Re: Long Island Public Policy Transmission Need Barrett – Valley Stream Scenario

NextEra Energy Transmission New York, Inc. (NEETNY) appreciates the opportunity to provide additional input and request clarifications on the Barrett – Valley Stream Scenario results and assumptions shared by NYISO related to the proposals submitted in responses to the Long Island Public Policy Transmission Need (“LI PPTN”) solicitation.

Figure 1: Empire Wind II Network Modeling

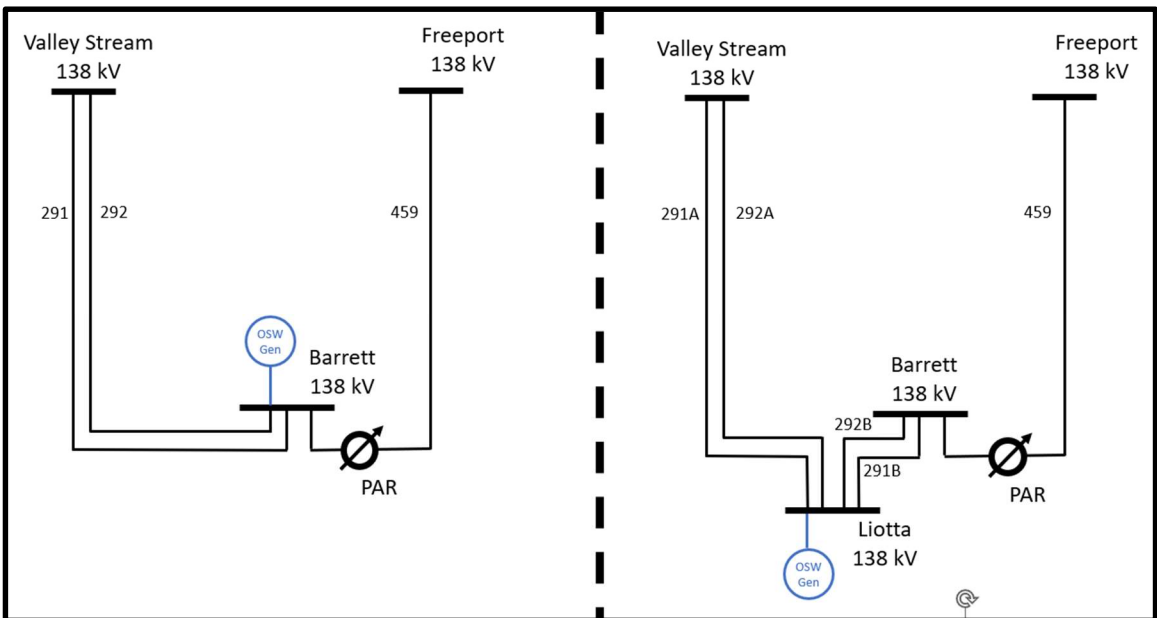
II. NYISO’s modeling of the Barrett – Valley Stream Scenario does not appear to be consistent with the expected interconnection configuration of Empire Wind II and the approved SUFs at the Liotta Substation.

NEETNY requests clarification on how Empire Wind II and the approved SUFs were modeled in the Barrett – Valley Stream Scenario, both in the base case and for each LI PPTN proposal.

In order to accurately assess the expected curtailment levels associated with Empire Wind II based on approved SUFs, NEETNY would expect NYISO to model Empire Wind II interconnecting to Liotta substation for all proposals as shown in Figure 1 below. The left diagram represents the model NEETNY believes NYISO is using in their production-cost simulation compared the right diagram where the Empire Wind II OSW generation is modeled at the updated Liotta 138 kV substation, consistent with the approved SUFs:

Since upgrades of the transmission lines from Liotta substation – Barrett 138 kV were not accepted as part of the approved SUF upgrades, and because no LI PPTN solution addressed these limiting elements, all LI PPTN proposals can expect significant curtailment due to these facilities without adjustments to the Point of Interconnection (“POI”) or additional network facilities upgrades. This curtailment is primarily driven by the loss on 138 kV lines out of the Liotta station resulting in overloads on the remaining 138 kV lines emanating from Liotta.

Figure 2: Production-Cost Savings Impact from Including Applicable NYC Constraints

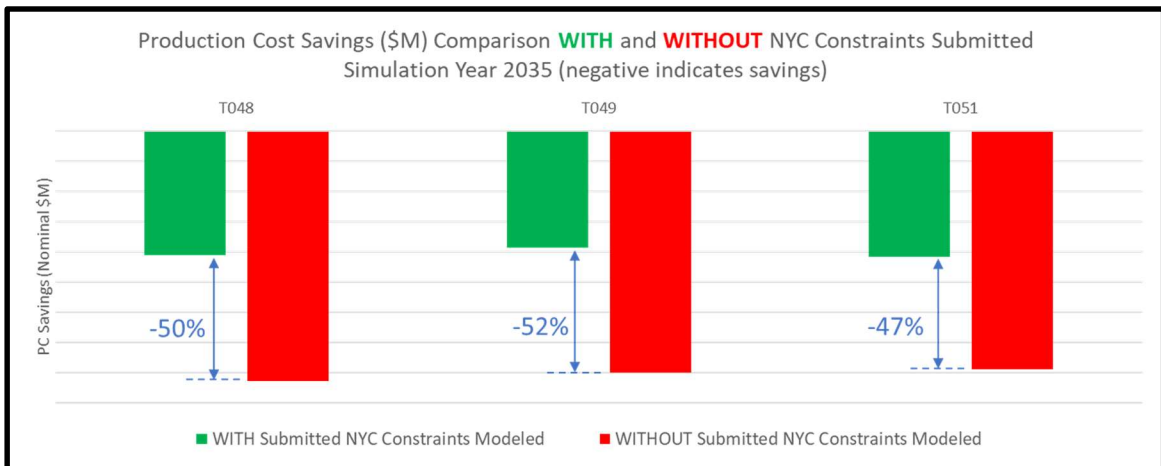
IV. If NYISO does not consider the additional NYC constraints previously provided by NEETNY for NYISO to include in their production-cost model, the production-cost savings for each proposal is not accurately captured since it omits applicable constraints in NYC.

NEETNY submitted comments to NYISO with a detailed list of NYC constraints that should be included in NYISO’s production-cost model for evaluation purposes on March 9, 2023. Significant changes to topology, such as the case with the proposed LI PPTN projects, can have a large impact

affecting power flows in highly networked areas such as the NYC transmission system. The power flow changes in NYC requires adding new constraints to the production-cost model to accurately capture congestion resulting from the proposals' topology changes. The list of supplemental NYC constraints has a significant impact on congestion and subsequently the production-cost savings for some LI PPTN proposals.

NEETNY performed a production-cost simulation sensitivity with and without the NYC constraints submitted and reviewed the top 20 constraints in terms of congestion rent across multiple proposals. For some proposals like T036 and T040, the NYC constraints contributed only 4% and 5%, respectively, of the proposal's top congestion; but for other proposals like T048 and T049, the NYC constraints contribute substantially at 89% and 97%, respectively. Figure 2 below shows the significant production-cost savings impact for proposals with a large proportion of NYC constraints from those sensitivity runs in 2035, from including the supplemental list of NYC constraints submitted to secure applicable constraints captured by NYISO's Security Constrained Dispatch (SCD). For proposals where NYC constraints contribute a low portion of congestion rent, there is minimal production-cost savings impact.
